This Field Safety Notice (FSN) contains important customer information for patient safety and for the safe use of *exoplan*, our software for implant planning and surgical guide design.

exocad product, commercial name: *exoplan*

Field Safety Notice #278955 related to Camlog Sleeve Library

Figure 1: Sketch comparing the distance situation between sleeve, implant and drill for the wrongly positioned sleeve (left) and the correct position of the sleeve (right).

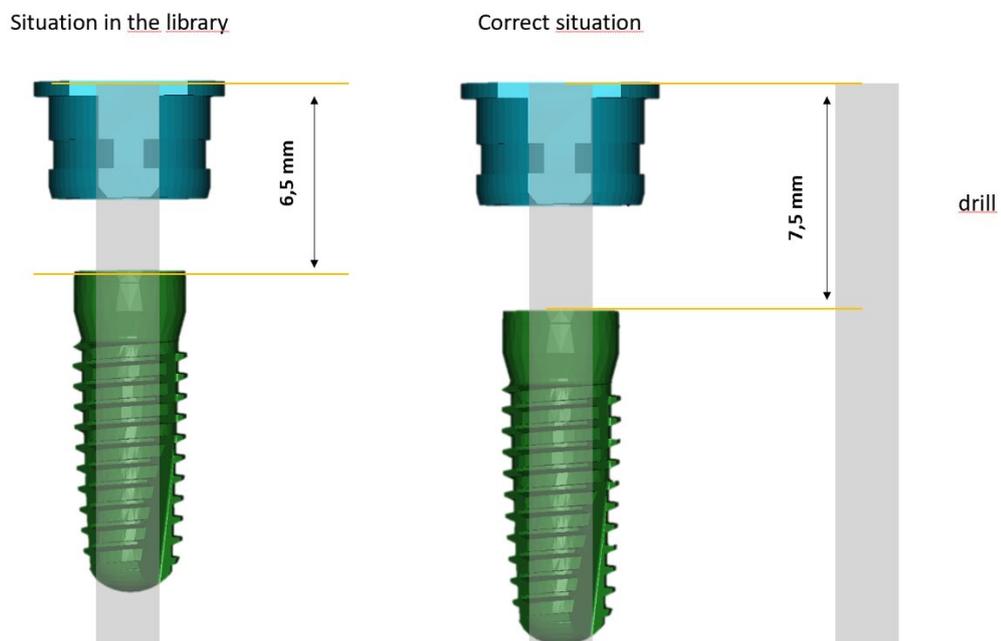
Affected libraries: The issue is an incorrect distance information contained in libraries CAMLOG_sleeve and Steco_StecoGuide_Compatible_Camlog_sleeve suggesting the usage of a surgical sleeve that results in a drill hole that is 1mm deeper than expected due to a dimensional error in the affected libraries.

During an update of data used in a library shipped with *exoplan* or made available on the download portal of *exocad*, it was found that the use of a specific combination of an implant, sleeve and surgical drill can result in a hole being drilled 1 mm deeper than expected.

- 4) New library versions of CAMLOG_sleeve and Steco_StecoGuide_Compatible_Camlog_sleeve have been released. Users can now download and install the new libraries.

Figure 3: Unsigned library message of a blacklisted CAMLOG® / StecoGuide library to the user when loading a scene file that already contains the affected library.

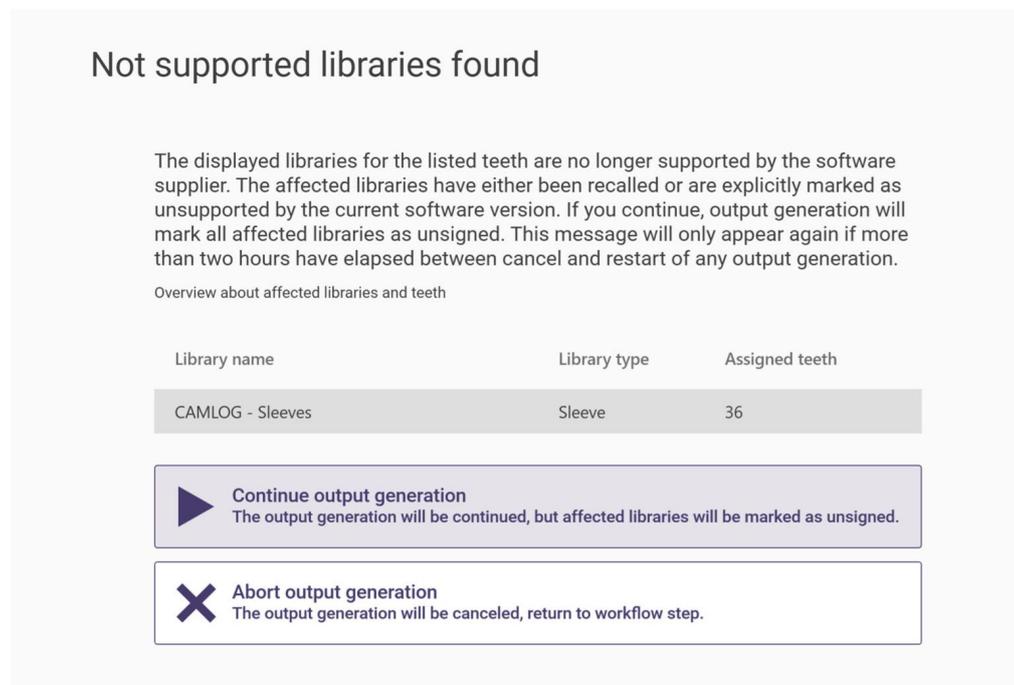
- 3) If an implant planning “scene file” (file containing all the information about a planning or design scene, e.g., workflow state, scene objects) is loaded into *exoplan* that previously used the blacklisted sleeve library in the implant placement planning, a warning message appears to inform the user about the unsigned library (see figure 3).
